Our ref: 11046
Council ref: A006351184

**RE: APPLICATION FOR MINOR CHANGE TO A DEVELOPMENT APPROVAL
15 & 21 WELLINGTON ROAD AND 31, 33, 35 & 37 HAMPTON STREET, EAST BRISBANE
QLD 4169 - 'KINGFISHER' AND 'HAMPTON YARDS'**

The requested minor change application relates to the current development permit A006351184, which is an approval for a Material Change of Use (Multiple Dwelling, Shop, Office and Food and drink outlet); and Building Work in the Flood Overlay.

Figure 1: Land dedications and proposed staging

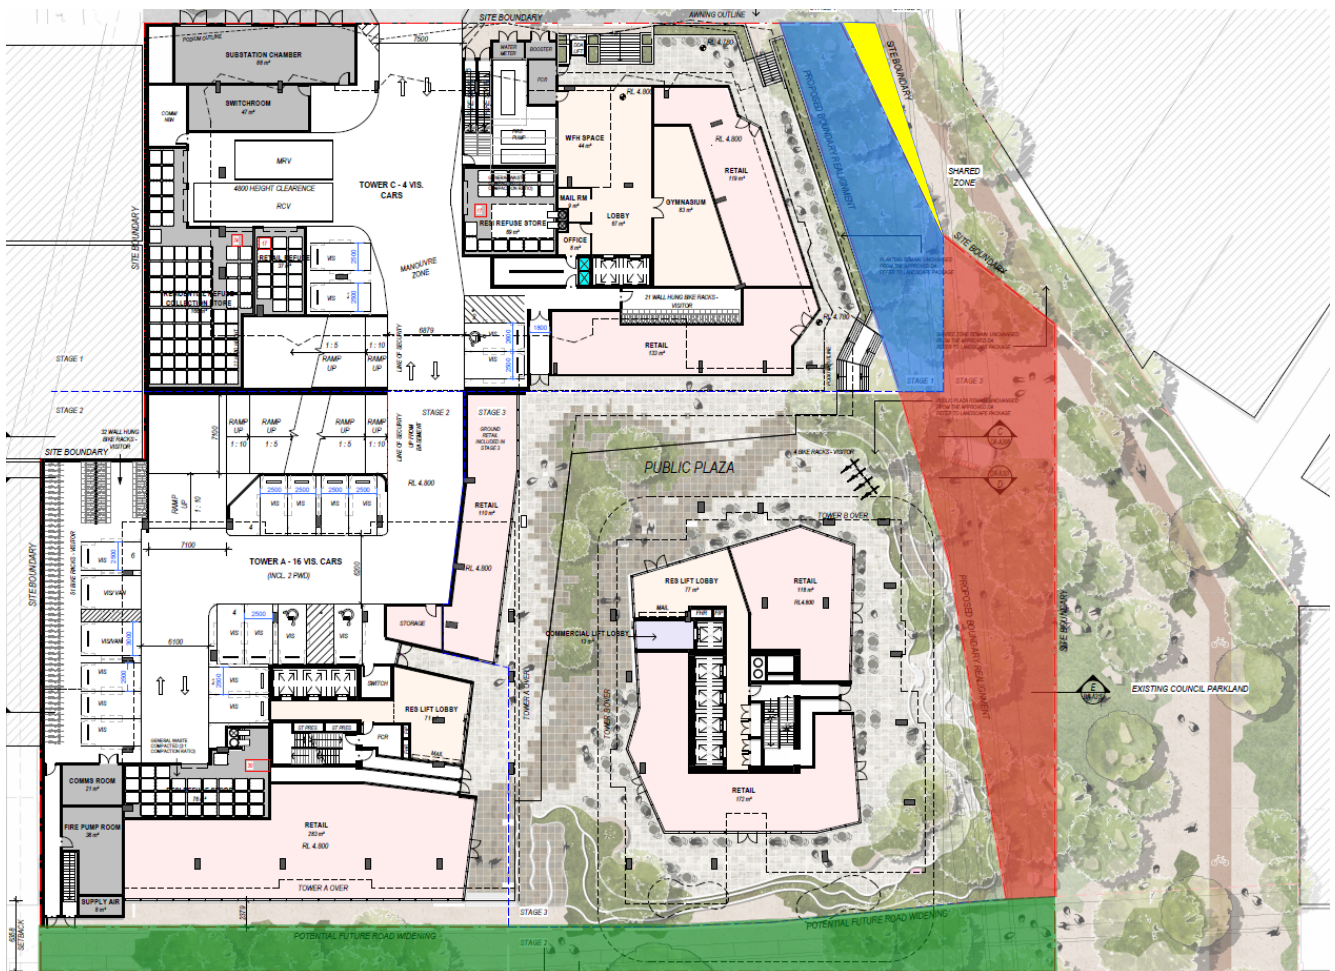
Notably, 'Kingfisher', which was previously proposed as part of Stage 3, is now intended to form part of Stage 1. This amendment reflects the applicant's desire to prioritise delivery of the building and facilitate its earlier construction and occupation. To support this outcome, the staging boundaries have been revised to enable 'Kingfisher' to proceed independently as the initial stage of the development.

The revised design removes the previously approved shared podium interface between 'Kingfisher' and Tower A and establishes each building as a discrete development component. The amendments also separate the basement and podium structures, with basement parking no longer proposed beneath 'Kingfisher' and instead consolidated beneath Towers A and B. This approach provides a more practical and logical staging arrangement while maintaining the functionality and development potential of the remaining stages.

The staging amendments involve revisions to the land dedication arrangement and timing. The Hampton Street road dedication remains within Stage 1 (shown in yellow below). Additionally, only a portion of the overland flow drainage area (shown in blue below) is included within Stage 1 to align with the revised staging layout and comprises the extent of the 'frontage' to 'Kingfisher'. The Wellington Road non-prejudice road widening is wholly contained within Stage 2 (shown in green below). The balance of the drainage corridor (refer to red shading below) is proposed to be provided as part of Stage 3, as it is intended to utilise Hampton Street and the laneway for construction access to Stage 2 & 3. Importantly, existing commercial buildings occupying Stages 2 & 3 will be removed within Stage 2; however, the Applicants preference is to dedicate the drainage reserve in Stage 3 once construction of Stage 3 is completed.

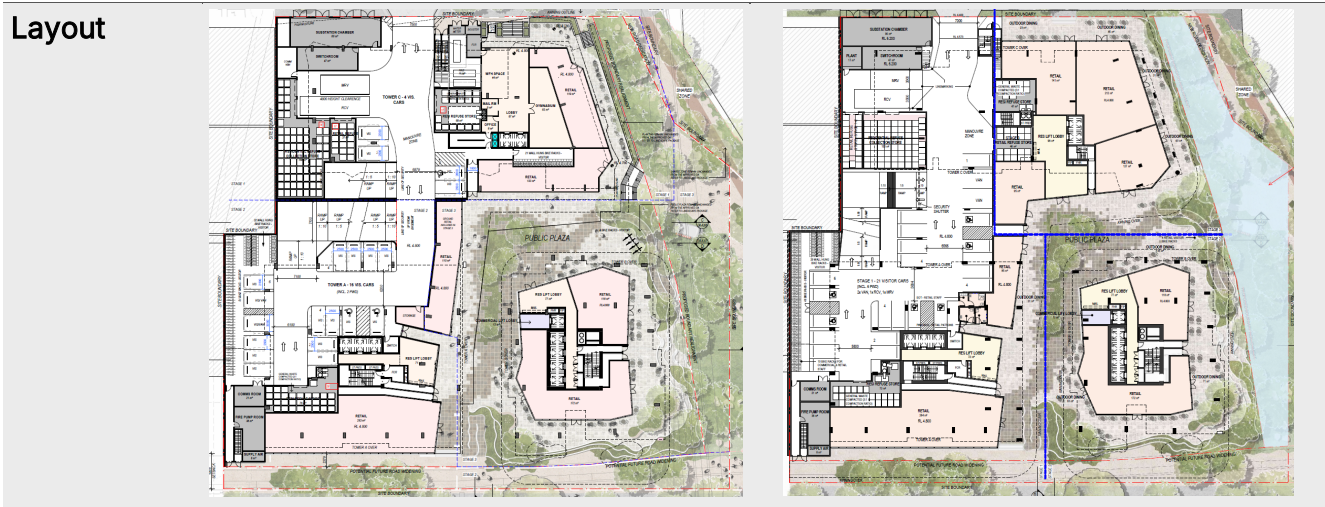
For Tower A, there is a slight increase in retail floor area, a minor redistribution of internal service areas, and a revised parking and bicycle provision, including fewer visitor spaces but an overall increase in visitor bicycle parking.

In addition, a further refinement relates to a portion of retail floor space within Tower A. Approximately 110m² of retail GFA has been deferred to Stage 3, as the space cannot be effectively utilised or operated independently until the future stage is delivered. This adjustment ensures a functional and cohesive retail outcome that aligns with the intended staging of the development, which has adopted a more logical configurate above and below ground compared with the existing approval.

The most notable changes occur within 'Kingfisher', where the layout has been substantially refined. This includes a reduction in retail floor area, a smaller lobby footprint, redistribution of service and refuse areas, and the introduction of additional resident amenity spaces such as a gymnasium and work-from-home facilities. Car parking and bicycle provision within 'Kingfisher' have also been rationalised. Following further development of detailed design, it was determined that this tower needs to do more of the 'heavy lifting' in terms of services and infrastructure (water booster, FCR, DDA access) for future Stages 2 & 3, which is the primary reason behind the changes to the retail footprint reduction. It was also determined that the most appropriate entry to the 'Kingfisher' lobby should be via Hampton Street instead of the pedestrian plaza.

Overall, the proposed changes to the Ground floor, predominantly relate to 'Kingfisher' and represent a refinement of the approved layout, including adjustments to tenancy sizes and service areas. Parking provision has been updated in response to the revised planning requirements. Notwithstanding these refinements, the proposal maintains consistency with the overall development intent.

Level 1

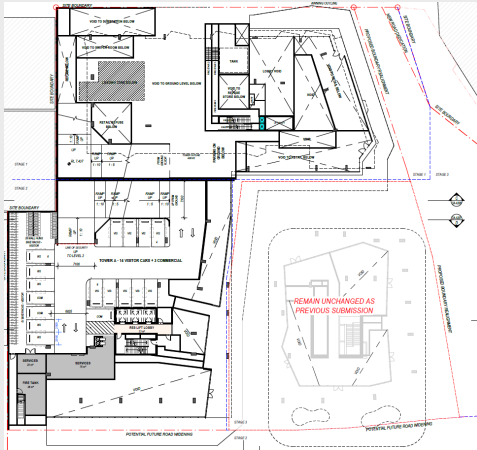
The redesign of Tower A, at level 1, has several changes to services and parking elements. The allocation of visitor car parking has been slightly reduced, with a portion reallocated to commercial spaces. Visitor bicycle parking provision has also been reduced from 108 to 79.

Tower B and C remain largely unchanged, continuing to present as a void area consistent with the approved.

Level 2

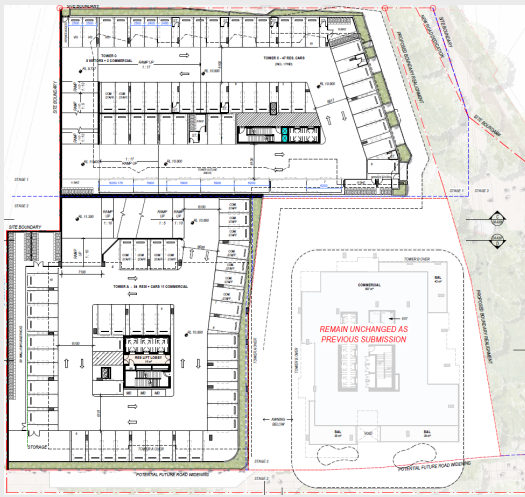
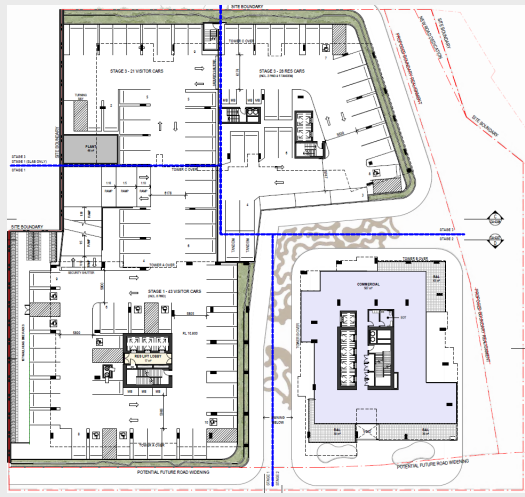
The redesign of Level 2 introduces several changes to parking and servicing arrangements within Towers A and C.

For Tower A, the layout has been reconfigured to rationalise parking and servicing functions. This includes a minor reduction in lobby area and a shift in parking allocation, transitioning from more visitor spaces to a mix of residential and commercial spaces.

The approved arrangement for Tower C, previously comprising residential and visitor parking, has been replaced with a revised layout incorporating a predominantly residential parking allocation, with some visitor and commercial spaces, together with the inclusion of resident bicycle facilities.

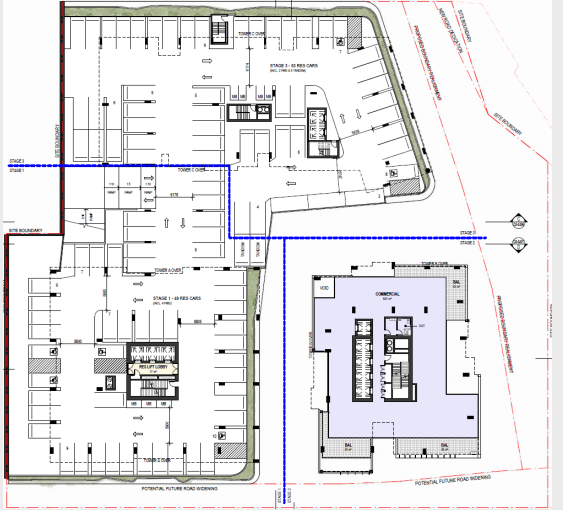
The amendments to Level 3 are limited to minor refinements across the towers, maintaining the overall parking yield and intended building function and design outcome. A detailed comparison of the approved and proposed development is provided in the table below:

Figure 4: Proposed building envelope vs approved envelope

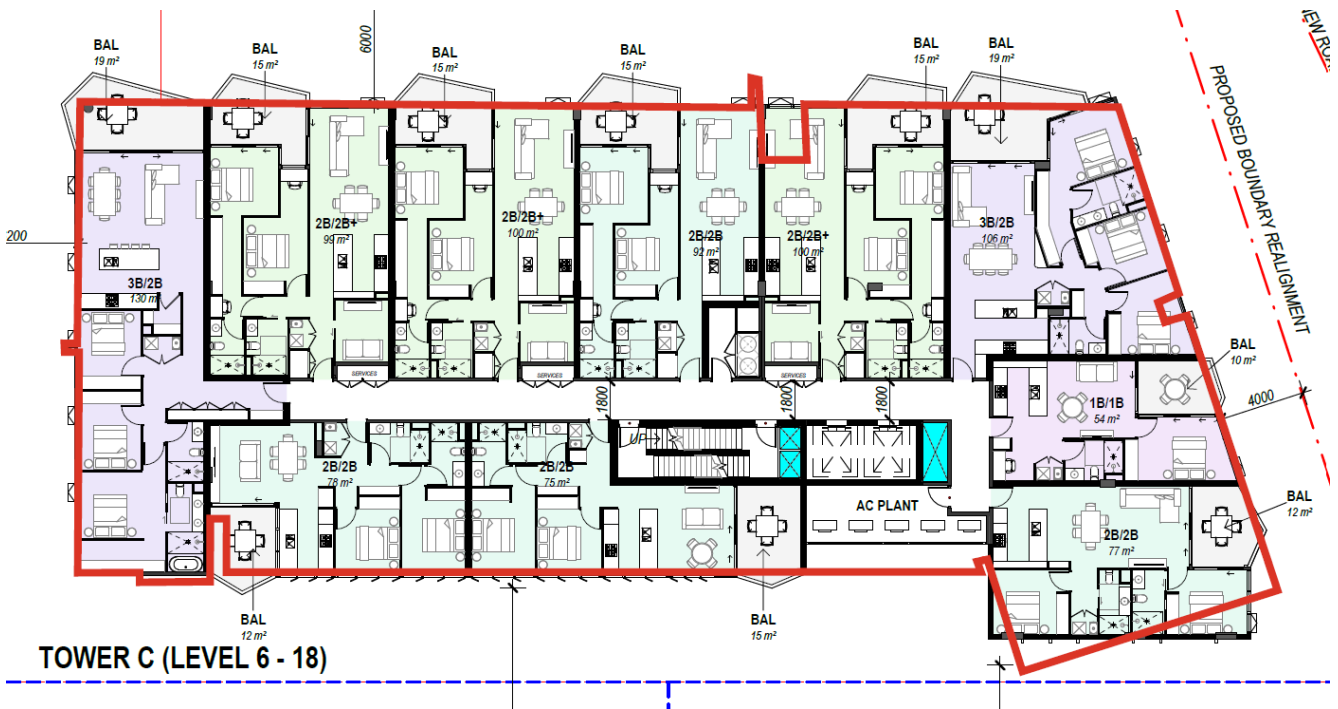
The approved building envelope (shown in red below) is proposed to be amended to reflect a revised configuration for Tower C. While the envelope has been adjusted in certain locations to accommodate the updated layout, these changes are relatively minor in nature. Importantly, the proposed amendments do not result in any material change to the established setbacks or building separation distances, which remain largely identical with the existing approval.
